UNITED STATES PATENT AND TRADEMARK OFFICE

Office Action Summary	Application No.	Applicant(s)	
	09/421,575	KASAI, ICHIRO	
	Examiner	Art Unit	
	Craig Curtis	2872

DETAILED ACTION

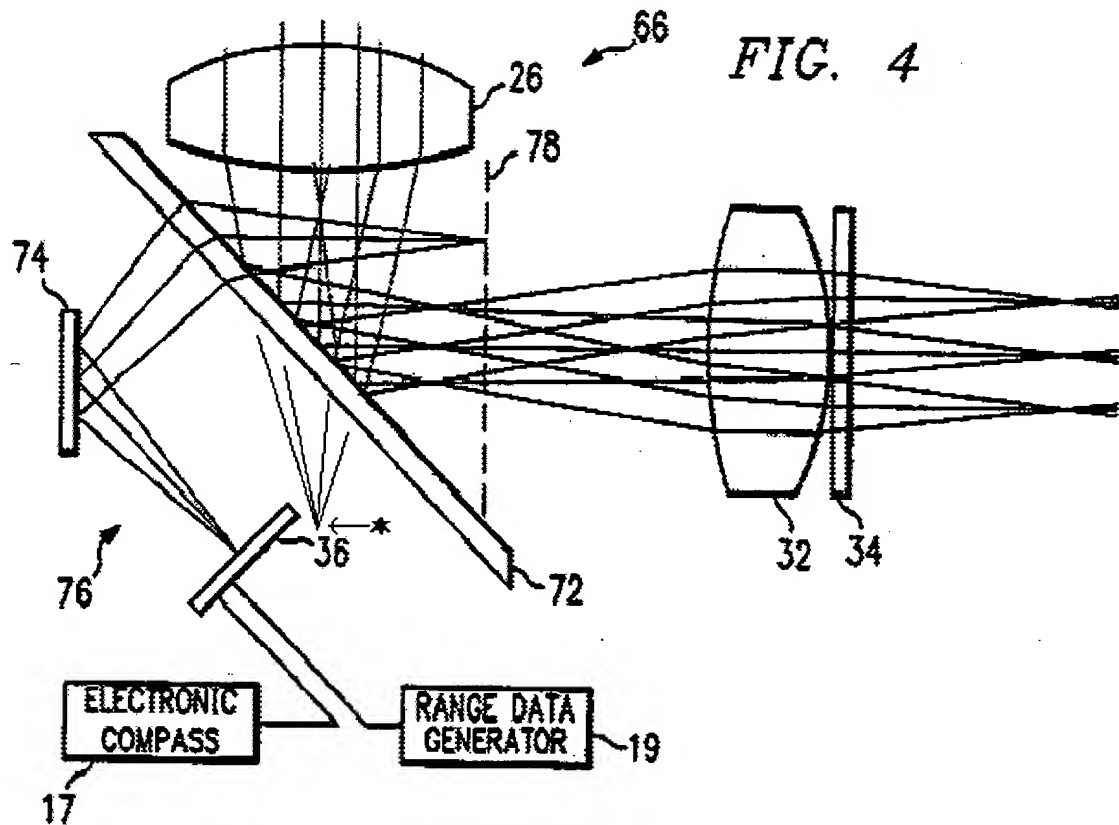
a hologram combiner (Fig. 4, 72) comprising a reflective-type hologram (a reflective- *and* transmissive-type, or transflective-type, actually) and having an optical power for constructing an equivalent surface (78) which is optically equivalent to the image surface at a different position than the image surface as viewed from the pupil (See annotated Fig. 4 below: esp. <---*); and

an information display device (76) for displaying information on the equivalent surface--
EXCEPT FOR the additional teaching wherein the hologram combiner transmits light from the image and reflects light from the information display device so that the image can be viewed with the information overlaid thereon. It is noted, however, that Wallace does disclose wherein the hologram

combiner reflects light from the image and transmits light from the information display device so that the image can be viewed with the information overlaid thereon, wherein the information displayed on the information display device is directed to the pupil as a virtual image (not presently depicted in the drawings of the instant invention).

the pupil.” That this is the case can be seen by reference to the annotated Fig. 4 of Wallace provided above. In this case, the equivalent surface is 78, and the image surface (virtual) is as depicted by (<---*) As clearly depicted in said annotated Fig. 4 of Wallace, equivalent surface 78 is both optically equivalent to the image surface (identified by <---*) and at a different position than the image surface as viewed from the pupil.

As is clearly set forth in Fig. 4 of the Wallace reference, the hologram combiner (72) is both reflective and transmissive (read: transfective): reflecting the light from the image and transmitting the light from the information display device (76). As is clearly set forth in the rejection of claims 1 and 10 above, one of ordinary skill in the viewing optical system art would certainly consider obvious the rearrangement of the relative positions of the information display device and light from the image (including, of course, lens 26), one to the other, for at least the purpose of, for the sake of example, increasing the brightness of light from the information display device via reflection from said hologram combiner, as opposed to the brightness of same realizable via transmission through said hologram combiner.

The hologram combiner (72) taught by Wallace not only has optical power (as can clearly be seen in Fig. 4, in which light diverging from folding mirror (74)--that is, light from said image display device--is made to converge following its transit through said hologram combiner, a result that could only be achieved if said hologram combiner had non-zero optical power); but focuses light from said information display device at plane 78, which is “optically equivalent” to the image surface at a different position than the image surface as viewed from the pupil in the same manner as that constructed by Applicant’s hologram combiner. (It is noted that the manner in which something can be described as being both “optically equivalent” and “at a different position than the image surface as viewed from the pupil” is met by Wallace by broadly interpreting “optically equivalent.”) In addition, as was noted in the previous Office action, Fig. 4 clearly depicts light from the information display device focussing at a different position (i.e., to the left of 78) than light from the imaging lens 26 (which focuses to the left of 78, denominated “common” or not) as viewed from the pupil (although the physical separation between focused information display device light and that from the imaging lens (read: image) is not set out in Wallace).
